Cable Test Requirements

The purpose of this presentation is to address some concerns in the cable test requirements proposed at working group on Dec.2, 1998.

Impedance TDR Measurement

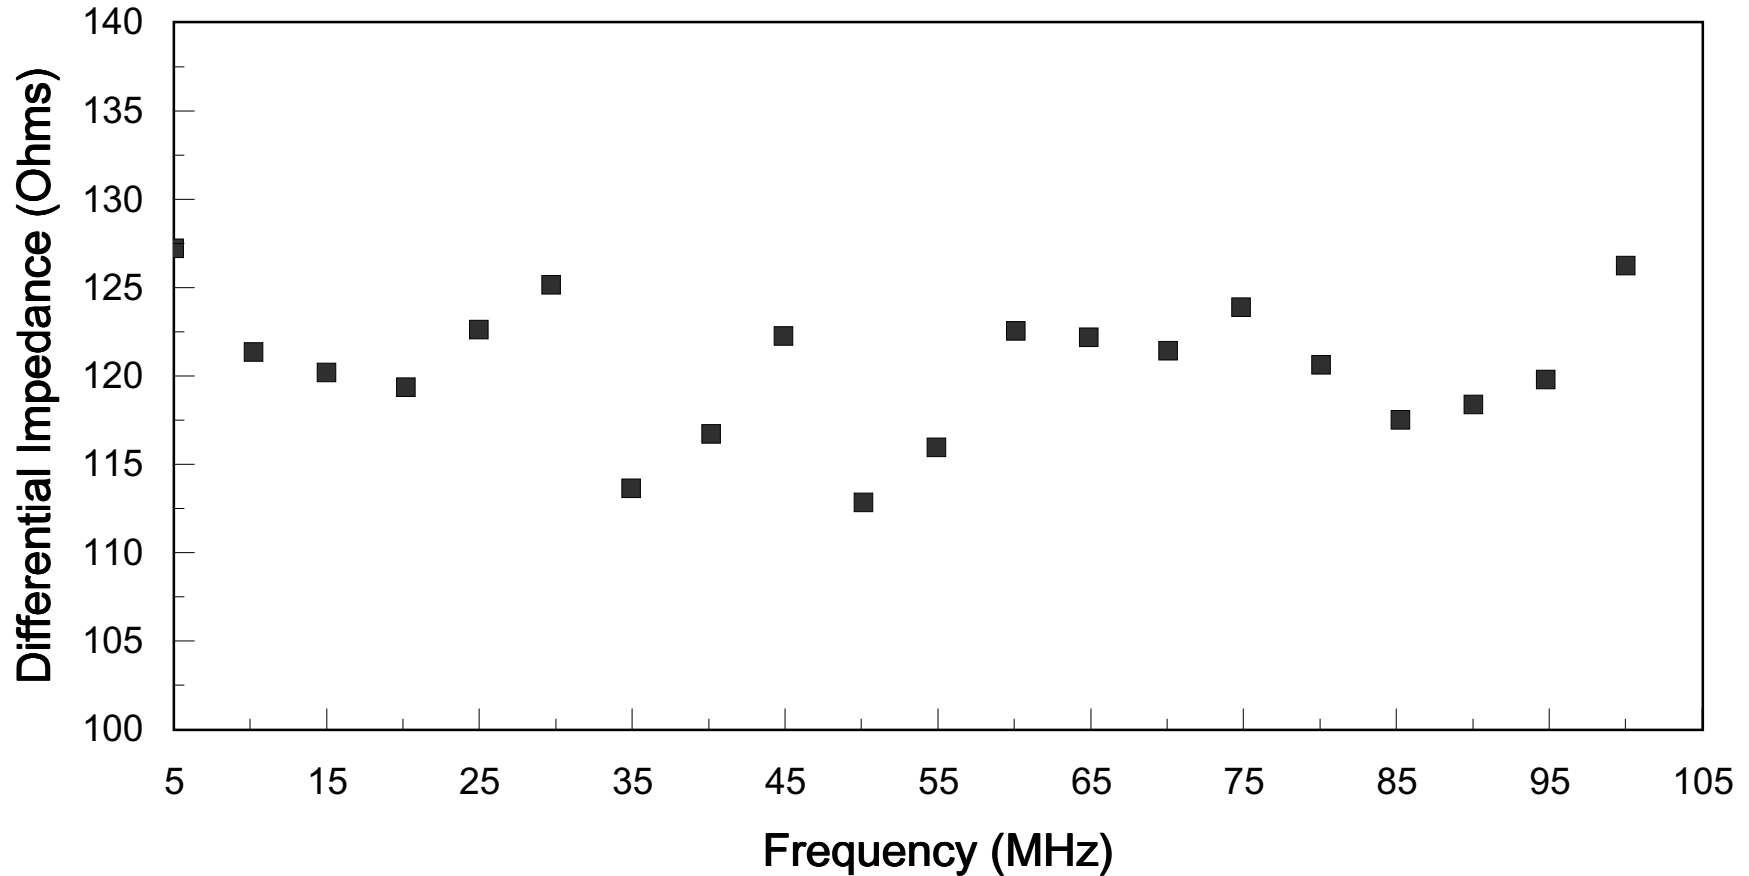
- We concern the following issues on impedance TDR measurements
 - Time Window need to be specified
 - Because @TDR, impedance is indepedant from the cable length so that the minimum testable cable length should be allowed, for example 10 ft. See attached figure for the comparision of impedance measurement on a 6 m and a 10 ft cable.
 - Rise time: we concerned 3 ns rise time is too slow for SCSI cable impedance measurement.

Imp. at Time domain vs Frequency domain

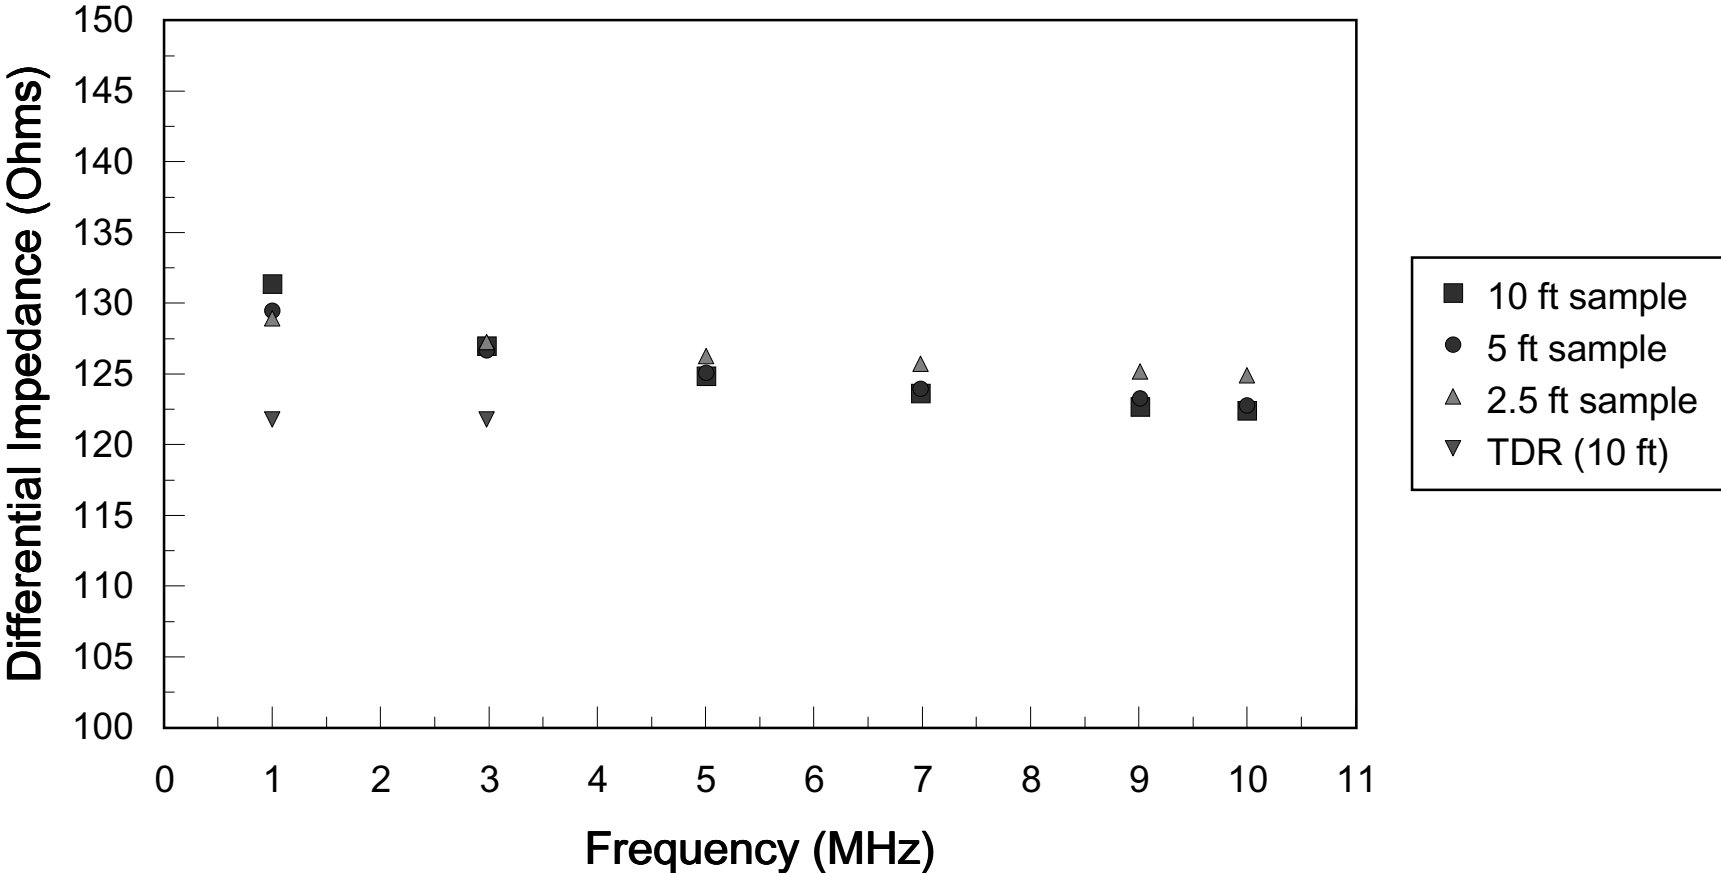
- TDR is more appropriate test method for impedance(Z) measurement on SCSI cables
 - at HF, Z is almost independent from frequency for the insulation compound used on SCSI cables
 - at LF, Z varies as frequency varies and Z @LF can not be controlled separately from Z @HF
 - in frequency domain, Z measurement is very sensitive to the test cable length. To accurately measure Z , an optimal test length and its measureable frequency range need to be carefully calculated. For a desired wide frequency range, several cable length needed to be tested and this is not practical at production level. See attached test data.

- for a desired wide frequency range, several cable length needed to be tested and this is not practical at production level.
- There is a limit on test frequency where the test cable length is too short comparing to the test fixture that accurate Z can be measured.
